REQUEST FOR LICENSE AMENDMENT PRIMARY & SECONDARY COOLANT SPECIFIC ACTIVITY
TO REVISE LIMITS ON REACTOR COOLANT AND SECONDARY COOLANT SPECIFIC ACTIVITY
FOR REQUESTED POWER UPGRATING TO 2300 MW.

PLANT NAME: H B ROBINSON - UNIT 2

H. B. ROBINSON STEAM ELECTRIC PLANT, UNIT NO. 2
DOCKET NO. 50-261
LICENSE NO. DPR-23
REQUEST FOR LICENSE AMENDMENT
PRIMARY AND SECONDARY COOLANT SPECIFIC ACTIVITY

FIGURE 3.1.4-1

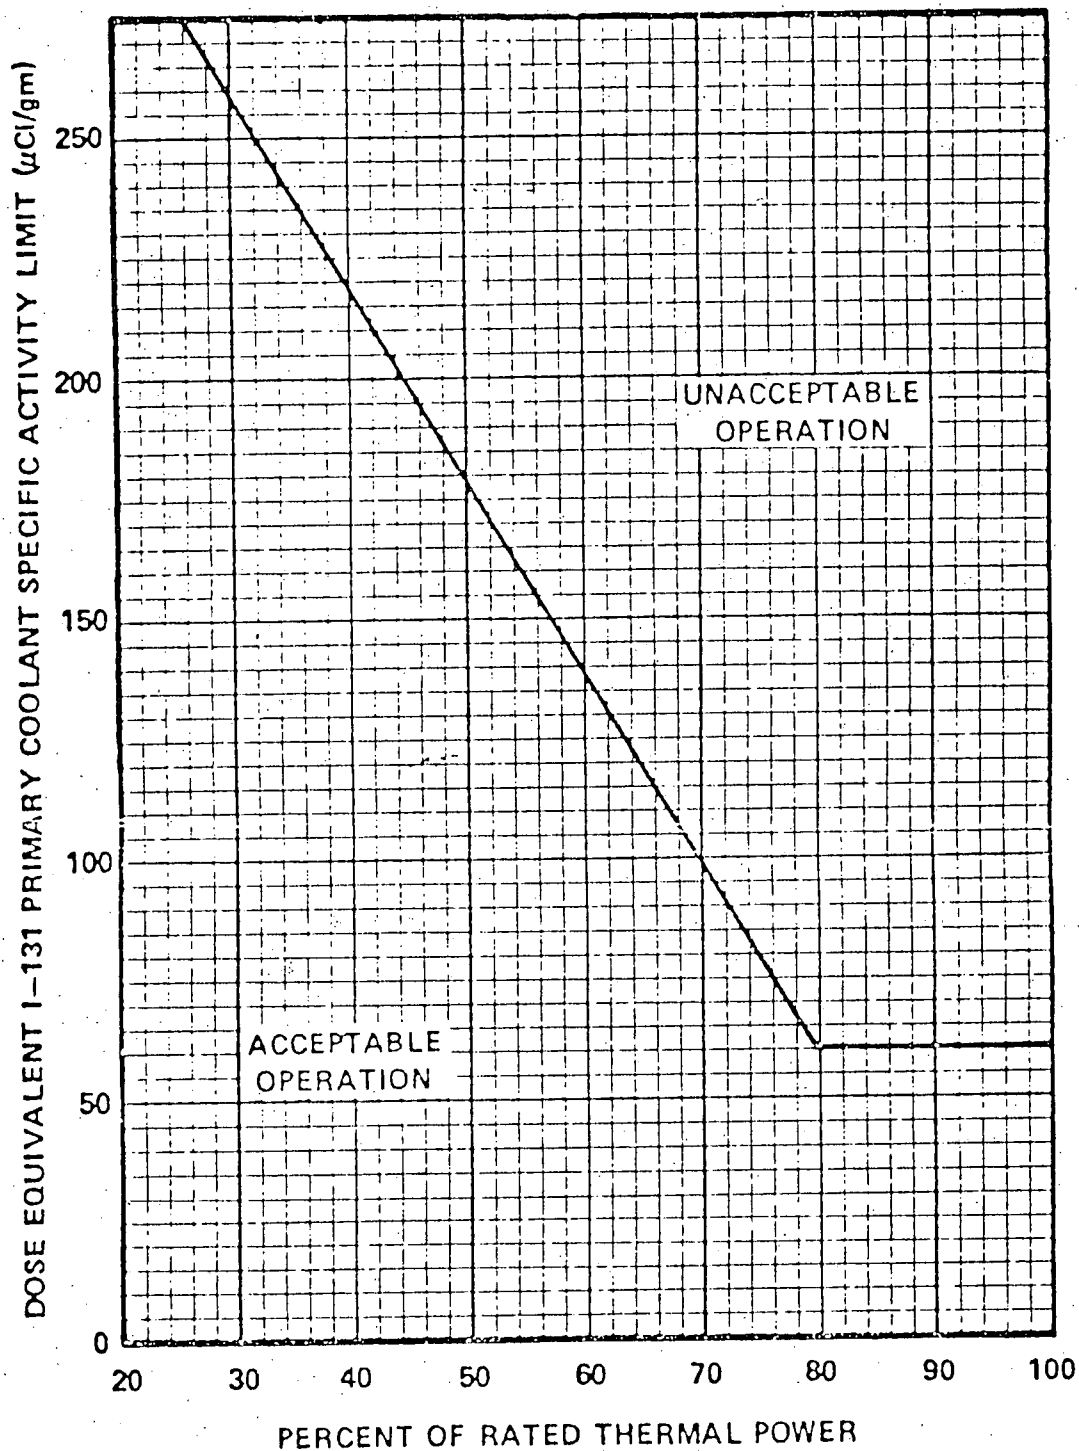
Whenever the reactor is critical or the average reactor coolant temperature is greater than 500°F , with the specific activity of the primary coolant $> 1.0 \mu\text{Ci}/\text{gram}$ DOSE EQUIVALENT I-131 but within the allowable limit (below and to the left of the line) shown on Figure 3.1.4-1, operation may continue for up to 48 hours provided that the cumulative operating time under these circumstances does not exceed 800 hours in any consecutive 12 month period. With the total cumulative operating time at a primary coolant specific activity $> 1.0 \mu\text{Ci}/\text{gram}$ DOSE EQUIVALENT I-131 exceeding 500 hours in any consecutive six month period, prepare and submit a Special Report to the Commission pursuant to Specification 6.9.2 within 30 days indicating the number of hours above this limit.

With the specific activity of the primary coolant $> 1.0 \mu\text{Ci}/\text{gram}$ DOSE EQUIVALENT I-131 for more than 48 hours during one continuous time interval or exceeding the limit line shown on Figure 3.1.4-1, be in at least HOT SHUTDOWN with $T_{\text{avg}} < 500^\circ\text{F}$ within 6 hours.

The statement permitting POWER OPERATION to continue for limited time periods with the primary coolant's specific activity $> 1.0 \mu\text{Ci}/\text{gram}$ DOSE EQUIVALENT I-131, but within the allowable limit shown on Figure 3.1.4-1, accommodates possible iodine spiking phenomenon which may occur following changes in THERMAL POWER. Operation with specific activity levels exceeding $1.0 \mu\text{Ci}/\text{gram}$ DOSE EQUIVALENT I-131 but within the limits shown on Figure 3.1.4-1 must be restricted to no more than 800 hours in any consecutive 12 month period, since the activity levels allowed by Figure 3.1.4-1 increase the 2 hour thyroid dose at the site boundary by a factor of up to 20 following a postulated steam generator tube rupture.
